**From:** "Williams, Dana M." <X2DANAWI@southernco.com>  
**To:** "Christian Araguas" <CJA2@nrc.gov>, "Mark Notich"  
<mdn@nrc.gov>, <michael.sackschewsky@pnl.gov>  
**Date:** 12/11/2006 6:15:53 PM  
**Subject:** Part 2 - NRC Submittal  
**cc:** "Tom C. Moorer" <TCMOORER@southernco.com>

45	The section on unavoidable adverse environmental impacts discusses social issues without specificity and never identifies any particular environmental concern. Clarify this discussion to include specific environmental adverse impacts for construction and operations, including an assessment of the before- and after-mitigation value of those impacts? Include the EJ effects of both construction and operations for each alternative site. Provide a table that displays all of the adverse environmental impacts of construction and operations (including human health effects); a description of each impact; all mitigation strategies to be undertaken by the applicant for that impact, the cost of mitigation, and the expected value of the unavoidable portion of that impact.
----	---

### NRC Question 114

Figure 1 – Average daily suspended sediment load for Savannah River at Clio, GA (USGS Gage No. 2198500)

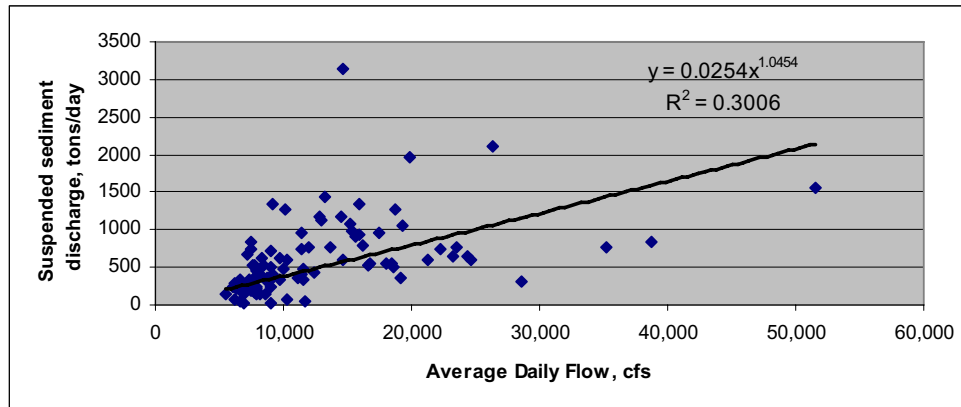
Provide estimated erosion characteristics and sediment transport rates, including bed and suspended load fractions, for the Savannah River near the site.

These data points are listed in Table 2 and are plotted in Figure 1 against the average daily discharge recorded for those days. There is only a slight correlation between average daily discharge in cfs and suspended sediment load in tons per day, so the suspended load data time series can not be extended with much reliability.
